**REQUEST**

Current Zoning: R-5 (single family residential)  
Proposed Zoning: MUDD(CD) (mixed use development, conditional)  
with 5-year vested rights

Approximately 0.517 acres located on the west side of the intersection of Seigle Avenue and E. 15th Street.  
(Council District 1 - Egleston)

The petition seeks to redevelop the site with up to 35 residential dwelling units, at a density of 68.6 units per acre.

- **Proposed Request Details**

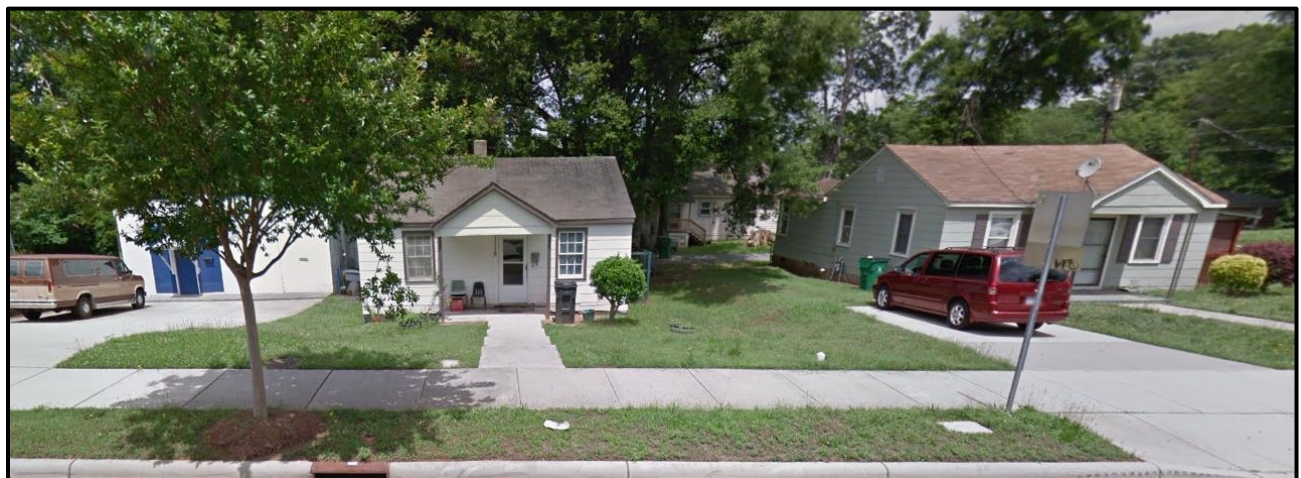
1. Reduce the density to not exceed five dwelling units per acre.
2. Remove the request for 5-year vested rights.
3. Amend Note 2A to delete commercial uses. If commercial space will be included specify the maximum square footage allowed.

4. Rebuild the receiving ramps at the corner of Seigle Avenue and East 15<sup>th</sup> Street to meet City of Charlotte and PROWAG standards.

5. Amend Note 5 to remove "in the sole discretion of petitioner."
6. Show and label required space for dumpster(s)/compactor and recycling, which is required to be set aside even if property owner and/or developer elects to use a private hauler for individual rollout cart service.

7. Amend Note 4D to delete all verbiage after "By Section 6.207 of the ordinance."
8. Specify Tree Save information under heading of Development Data.
9. Correct the discrepancy between the number of parking spaces provided and the parking ratio specified in the site development data table.
